Subject: WATER IN REAR COMBINATION LIGHT	Bulletin No: 09-005/09
	Last Issued: 1/30/2009

- This bulletin supersedes the previous bulletin 09-014/07, issued 4/13/2007. The DESCRIPTION, REPAIR PROCEDURE, PART(S) INFORMATION and WARRANTY INFORMATION sections have been revised.
- Changes are noted below in Red beside the change bar.

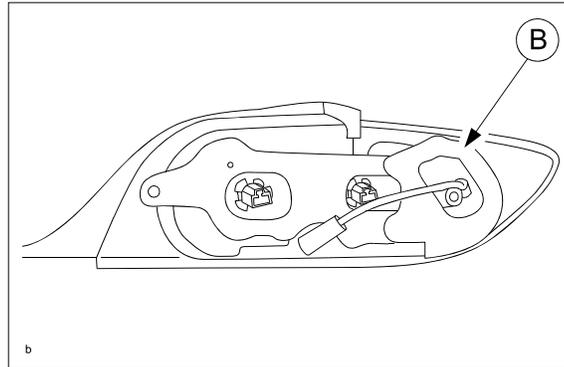
1. Remove and discard the existing gasket and replace with revised gasket (B).

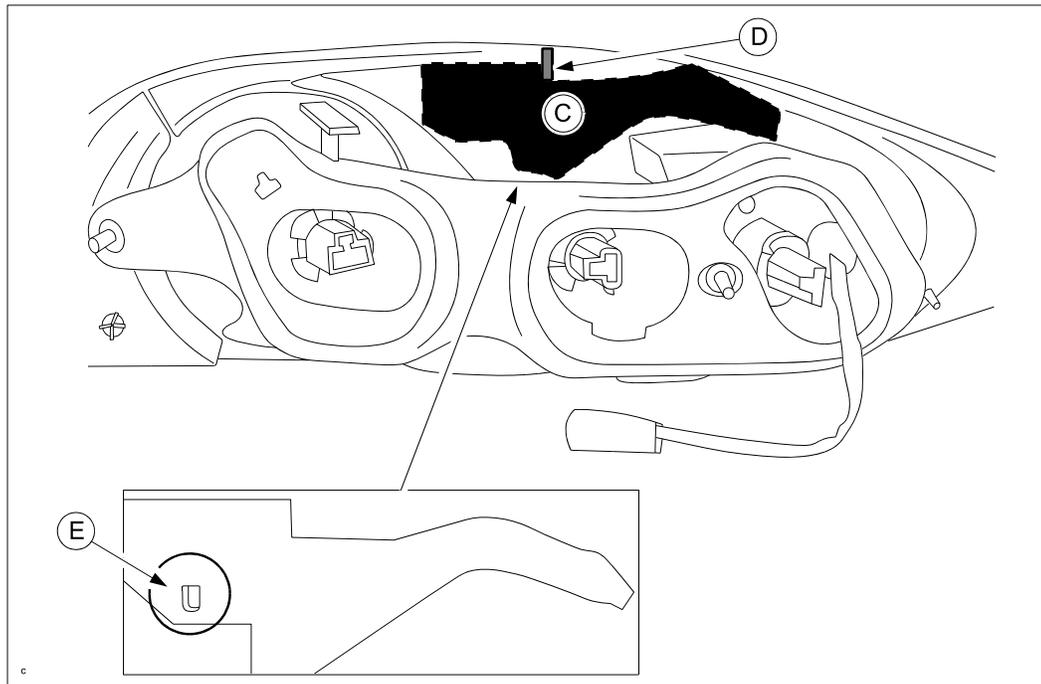
8. Attach pad (C) to rear combination lamp by aligning the pad corner to the rib (D).

- Mark (E) identifies if pad is for left or right rear combination lamp (left pad shown).
